**ZONING AMENDMENT,
& SUBDIVISION STAFF REPORT****Date: March 6, 2008**

<u>APPLICANT NAME</u>	Ball Healthcare Services, Inc.
<u>SUBDIVISION NAME</u>	Twin Oaks Subdivision
<u>LOCATION</u>	North, East, and South sides of Crawford Lane at its East terminus.
<u>CITY COUNCIL DISTRICT</u>	District 2
<u>PRESENT ZONING</u>	R-1, Single-Family Residence District and B-1, Buffer Business District
<u>PROPOSED ZONING</u>	B-1, Buffer Business District
<u>AREA OF PROPERTY</u>	1 Lot / 7.2± Acres
<u>CONTEMPLATED USE</u>	<p>Subdivision approval to create 1 lot, and Zoning approval to rezone the site from R-1, Single-Family Residential, and B-1, Buffer Business, to B-1, Buffer Business, to eliminate split zoning in a commercial subdivision.</p> <p>It should be noted, however, that any use permitted in the proposed district would be allowed at this location if the zoning is changed. Furthermore, the Planning Commission may consider zoning classifications other than that sought by the applicant for this property.</p>

SITE PLAN

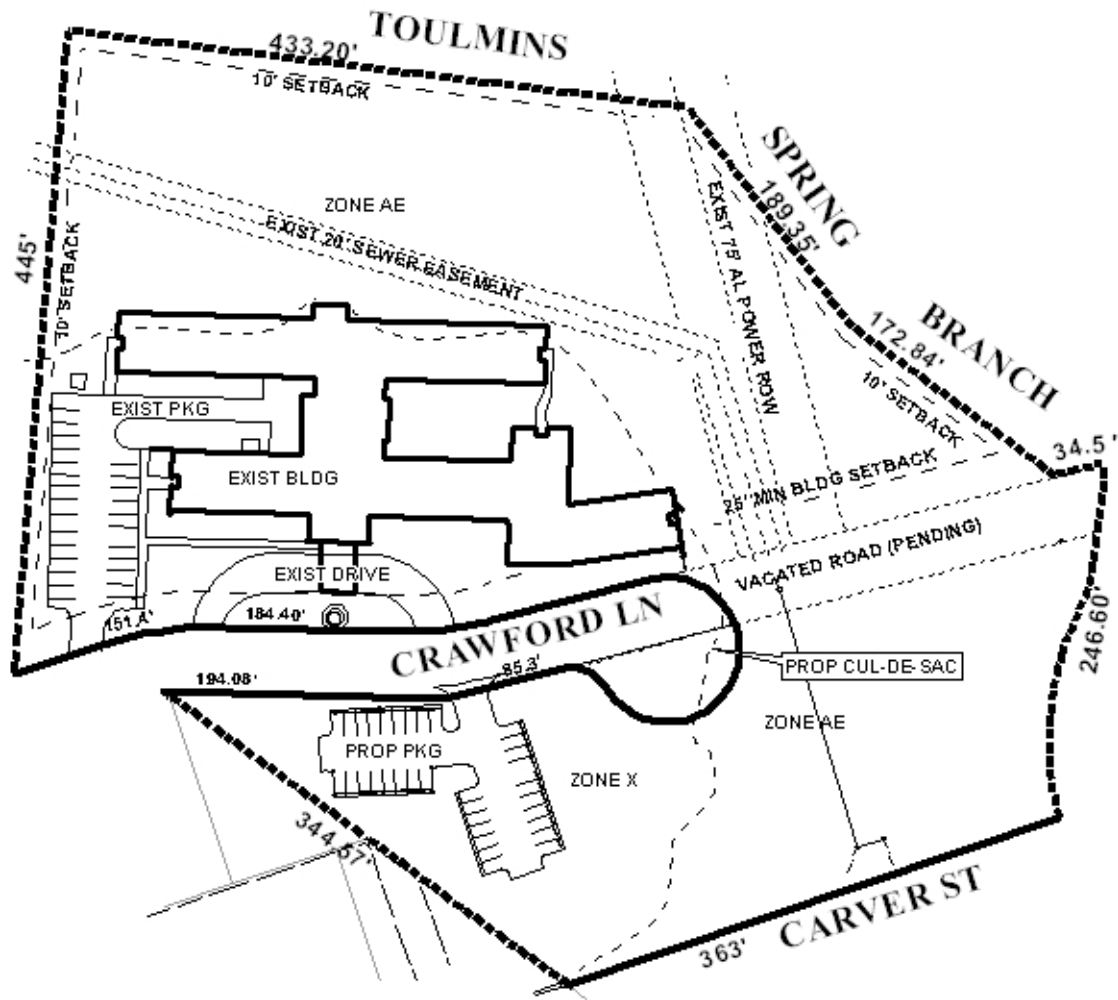
Regarding the proposed subdivision, the site is served by public water and sewer services and would meet the minimum requirements of the subdivision. The completion of the Vacation process for the unopened East terminus of Crawford Lane would be required to make the applicant's properties contiguous prior to the signing of the final plat. The plat indicates a proposed cul-de-sac without a center median at the East terminus of the existing open Crawford Lane right-of-way. As the current right-of-way is indicated to be 45.6', dedication would be required along both sides of Crawford Lane to provide 25' from centerline. The cul-de-sac is indicated to be 100' in diameter; however, the 2003 International Fire Code Standard requires a 120' right-of-way diameter for cul-de-sacs without a center median. Therefore, the plat should be revised to indicate a 120' diameter cul-de-sac. Construction of the cul-de-sac to City standards would be required prior to the signing of the final plat. The subdivision also has frontage along the North side of Carver Street, currently with a 40' right-of-way width; therefore,

dedication would be required to provide 25' from the centerline of Carver Street. A 25' minimum building setback line is indicated along Crawford Lane as measured from the current right-of-way line. This should be revised to indicate a 25' minimum setback as measured from any required dedication. A 25' minimum building setback along the North side of Carver Street should also be indicated, as measured from any required dedication.

As a means of access management, a note should be placed on the final plat stating the site is limited to the three existing curb cuts along the North side of Crawford Lane, and two curb cuts along the South side of Crawford Lane, with the size, location and design of all curb cuts to be approved by Traffic Engineering and conform to AASHTO standards. A note should also be required stating that access to Carver Street is denied.

The lot is labeled with its size in acres and this should also be indicated on the final plat, or a table should be furnished providing the same information.

The site is bounded on the West by residential zoning. As the site is intended to be developed commercially, the provision of appropriate residential buffers required by Section 64-4.D.1. of the Zoning Ordinance, such as a 6'-high wooden privacy fence or 10'-wide landscaped buffer should be required.

- 1) completion of the Vacation process for the unopened East terminus of Crawford Lane;
- 2) dedication along both sides of Crawford Lane to provide 25' from centerline

- 3) revision of the plat to indicate a 120' diameter cul-de-sac without a center median;
- 4) construction of the cul-de-sac to City standards prior to signing the final plat;

- 5) dedication to provide 25' from the centerline of Carver Street;
- 6) revision of the plat to indicate the 25' minimum building setback line as measured from any required dedication along Crawford Lane and Carver Street;

- 7) placement of a note on the final plat stating that the site is limited to the existing curb cuts on the North side of Crawford Lane, and two curb cuts on the South side of Crawford Lane, with the size, location and design of all curb cuts to be approved by Traffic engineering and conform to AASHTO standards;

- 8) placement of a note on the final plat stating that access to Carver Street is denied;
- 9) labeling of the lot with its size in acres, or the furnishing of a table on the plat providing the same information;

- 12) placement of a note on the final plat stating the provision of appropriate residential buffers required by Section 64-4.D.1. of the Zoning ordinance, such as a 6' wooden privacy fence or 10'-wide landscaped buffer are required; and
